TECHNICAL NOTE No. 001-2005

**MODEL: V11 Ballabio – Cafè Sport – Cat 2003-2005**

**SUBJECT: New tachometer cable**

Picture 1

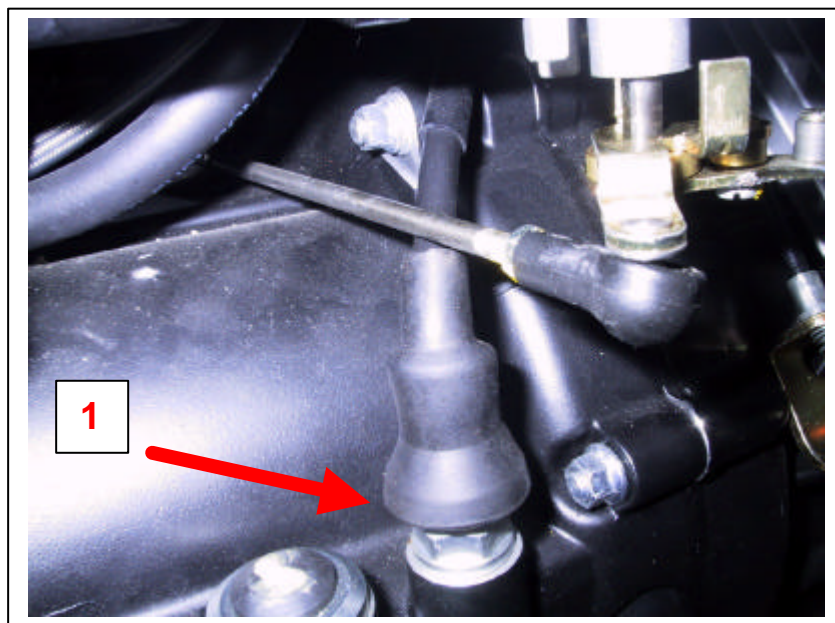
We have ascertained that on the above vehicles, that are equipped with the return cable for the throttle cable (part no. 01603380), the tachometer cable might break due to the angle with which it is fixed to the engine (1). (Picture 1)

In case the cable needs replacing, spare new cables are available part no. 01760481 (supersedes part no. 01760480) and part no. 01760492 (supersedes part no. 01760491), that are fitted to the engine at a wider angle (20°).

Picture 2

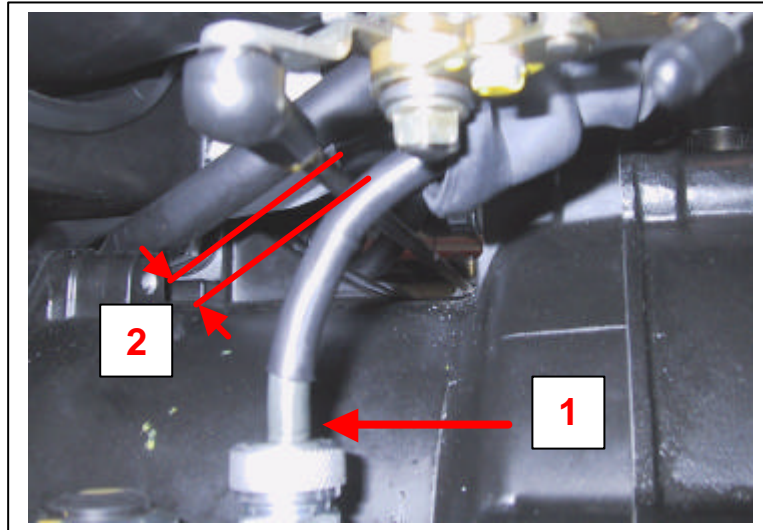
When fitting the cable, turn metal fitting (1) so to set maximum distance (2) between tachometer cable and throttle body linkage (minimum 5 mm). (Picture 2)

Should it be impossible to obtain specified distance, change throttle body position: loosen the clips on rubber hoses and position the throttle body in such a way as to ensure the minimum distance required between tachometer cable and throttle body linkage.

Picture 3

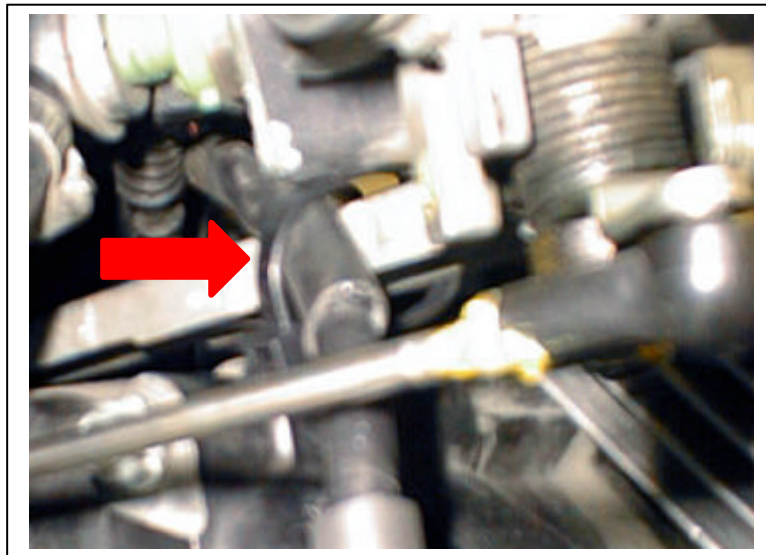
Ensure the tachometer cable is correctly in place: it **should be routed at the left of the throttle body linkage**, it is recommended to tie the cable to it to keep it in position; do not tighten too much. (Picture 3)
